Service Bulletin No. 430

MODEL	J4500 Series	TYPE	Field Change Program	SECTION/GROUP	3-Body	DATE
SUBJECT	KIEL PASSENGER SEAT					
CONDITIONS

Ref. MCI NHTSA Recall No.:15V-862

Figure 2. Correct installation of mounting hardware.

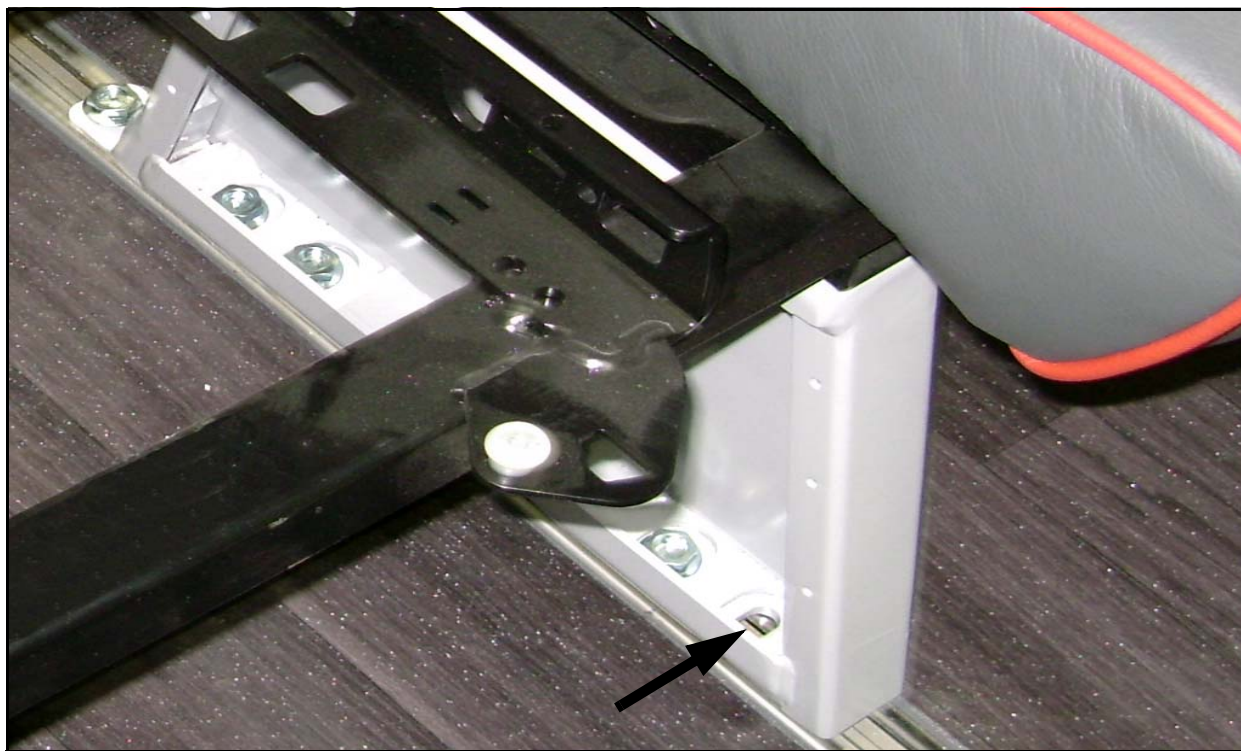
If the mounting hardware is installed correctly as shown in Figure 2, no further action required. Re-install the cover panel to the seat base using the two (2) snap fasteners, p/n 19-05-0304.

Figure 3. Incorrect installation of mounting hardware.

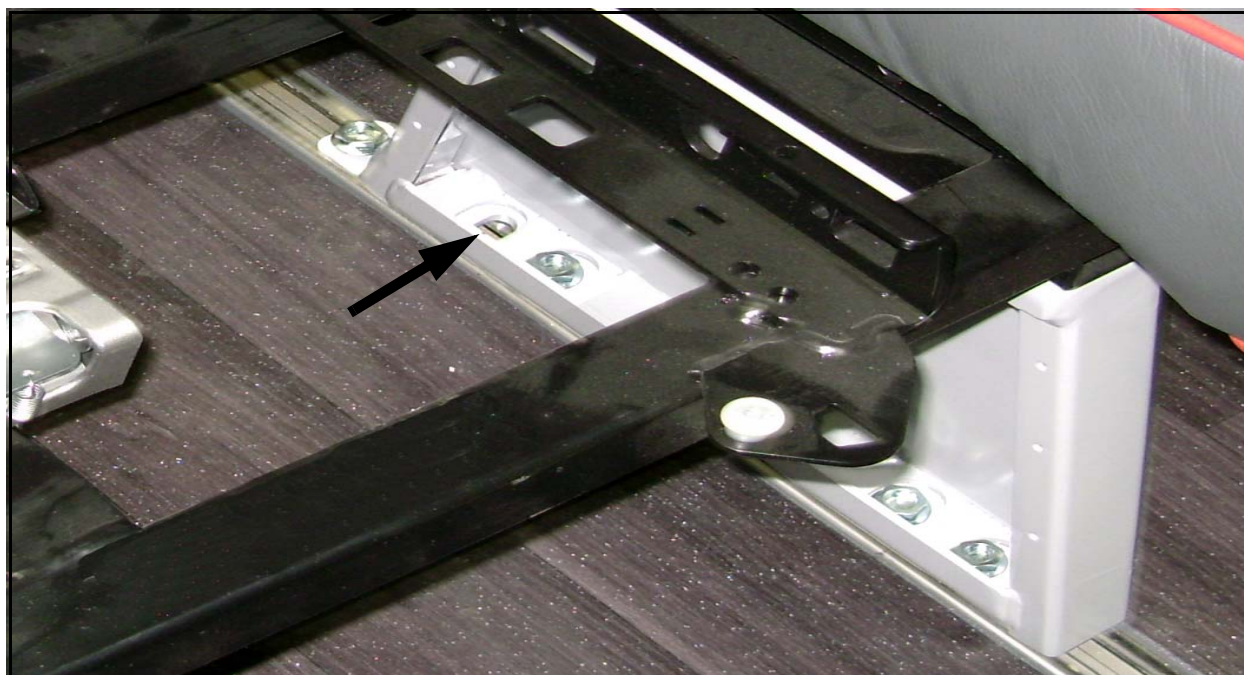
Motor Coach Industries ("MCI") has become aware that a bolt fastening the seat pedestal to the seat track on the J4500 coaches listed below may have been installed in the incorrect location.

Incorrect mounting fastener location at the production plant.

If the mounting hardware is installed incorrectly as shown in Figure 3, proceed to Step 7.

8. Locate the passenger seat mounting hardware on the coach sidewall. Remove and discard the nuts from the mounting t-bolts (refer to Figure 7).
9. Locate the passenger seat mounting hardware on the seat base (refer to Figure 3). Remove and discard the nuts from the mounting t-bolts.

Figure 4. Floor track t-bolt locked angle.

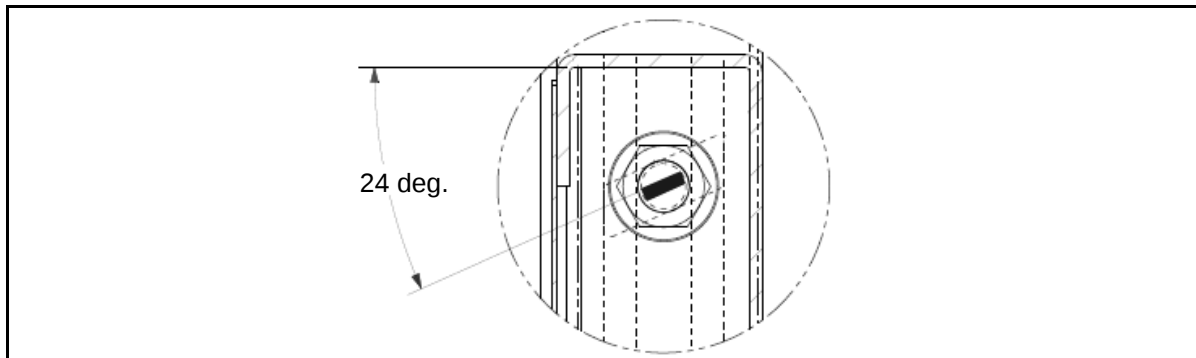
For proper installation, do not install a t-bolt at the location marked with an X in Figure 5.

13. Orient and align the four (4) new t-bolts, p/n 3R-11-32, in the floor track. Slide under the seat pedestal until the t-bolt is aligned with the seat pedestal hole at the four (4) locations shown in Figure 5. Rotate the t-bolt to lock into the floor track. The notch on top of the t-bolt should be at 24 degrees when locked in place (refer to Figure 4).

Figure 6. Sidewall track t-bolt locked angle.

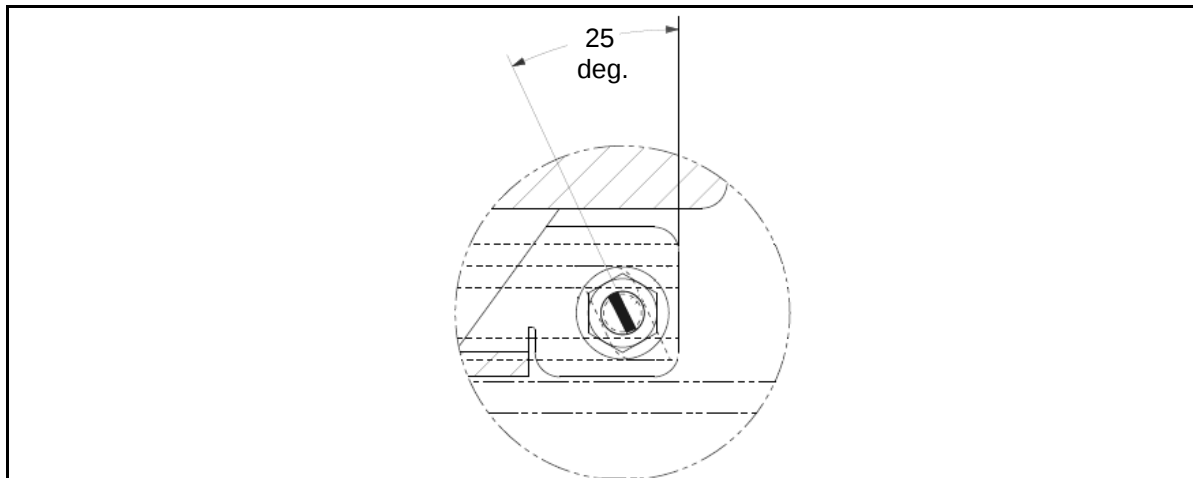
14. Orient and align three (3) new t-bolts, p/n 3R-11-24, with the marks made on the sidewall track. Rotate the t-bolt to lock into the sidewall track. The notch on top of the t-bolt should be at 25 degrees when locked in place as shown in Figure 6.

Figure 7. Coach sidewall t-bolt location.

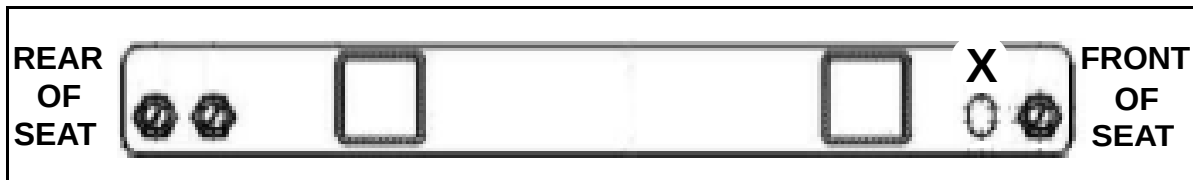
For proper installation, do not install a t-bolt at the location marked with an X in Figure 7.

15. Lower and orient the seat in its original position.
16. Install a new nut, p/n 19-3-226, on the floor track and sidewall t-bolts. Torque the sidewall and floor track nuts to 54-60 ft-lbs.
17. Orient the cover panel to the passenger seat base. Carefully install the two (2) snap fasteners, p/n 19-05-0304, to secure the panel to the seat base.
18. Repeat steps to the remaining fixed, non-sliding passenger seat bases.
